Flight Procedures Cover Page	Task Action: Abbreviated Amendment	Task Type: STAR	Estimated Chart Date: 12/02/2021	APWS Task ID: 1CBCDC5FDA3F42B6AD4EC57267F90092	APWS Project ID: 4C01CB00BACD4C4A93192B59FF19DF00
Procedure: MELBOURNE TWO STAR		Enroute: YES	Specialist: Gracey, Dean		Agreement Number:
Airport ID: KPBI			Airport City: WEST PALM BEACH		State: FL
Facility ID:	Facility Type:	Flight Inspection Remark Type:			
<div>Procedure Comments: PBI - POST IMPLEMENTATION.</div> <div>PROCESSED IAW AIRCRAFT OPERATIONS GROUP (AJF-10) MEMO, APRIL 29, 2020 SUBJECT: FLIGHT INSPECTION REVIEW NOT REQUIRED.</div> <div>CONTACT ALLAN WILL AJV-A423 (405) 954-6103.</div> <div>08/05/2021</div> <div>QUALITY 14 CHECKED</div> <div>QUALITY 15 CHECKED</div>

Subject: Approval Request; Memorandum Dated 01/25/2021

Subject: Letter of Approval (LOA) Request: MELBOURNE STAR, KPBI

ARRIVAL ROUTE DESCRIPTION

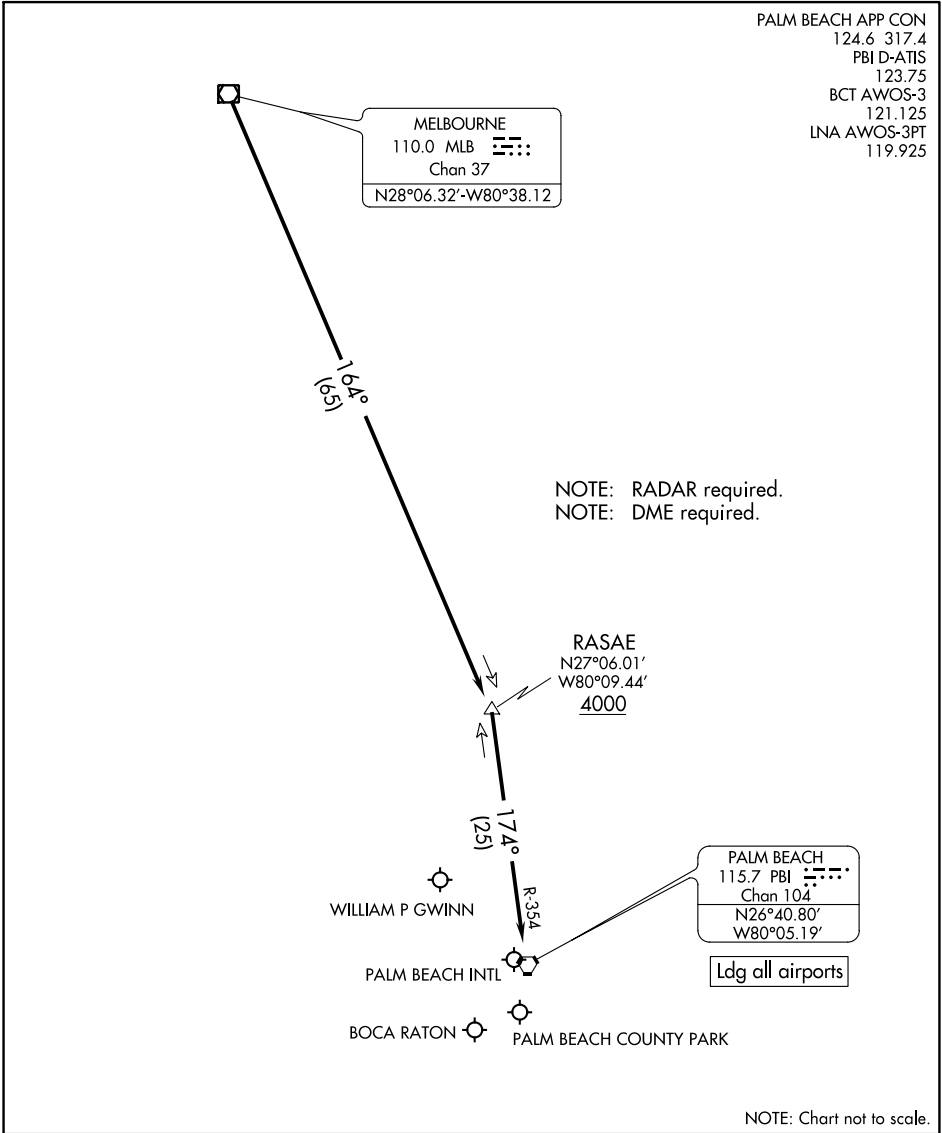
LANDING ALL AIRPORTS: From over MELBOURNE VOR/DME (MLB) R-164° to cross RASAE at or above 4000, then on PALM BEACH VORTAC (PBI) R-354° to PBI VORTAC. Expect RADAR vectors to final approach course.

The termination fix for the MELBOURNE Standard Terminal Arrival Route (STAR) is Palm Beach VORTAC (PBI).

Currently, FAAO 8260.3D, PARA 2-2-7f requires an altitude at the termination fix and that altitude must be at or above the minimum vectoring altitude (MVA) and/or minimum IFR altitude (MIA) (as applicable).

The current runway configurations at KPBI determines the altitude assignments at the various fixes along the STAR. The MELBOURNE STAR serves several airports and multiple runway configurations and flows at KPBI with varying altitude restrictions making a permanent altitude restriction impractical at the termination fix PBI. FAAO 7110.65 PA RA 4-5-6 and 5-6-1 requires altitude assignments above the minimum IFR altitude / minimum vectoring altitude (MIA/MVA) so the absence of an altitude does not introduce any new risk into the system.

Therefore, the South Florida District is requesting a Letter of Approval (LOA) to continue to utilize PBI for the MELBOURNE STAR without published or mandatory altitudes.

Your request to deviate from the requirements of FAAO 8260.3E, Paragraph 2-2-7f, specifically, the requirement to establish an altitude at the termination fix for Standard Terminal Arrivals (STAR's) that authorize radar vectors is temporarily approved until December 2, 2021 and forwarded for your action. This temporary approval is applicable to the following procedures:
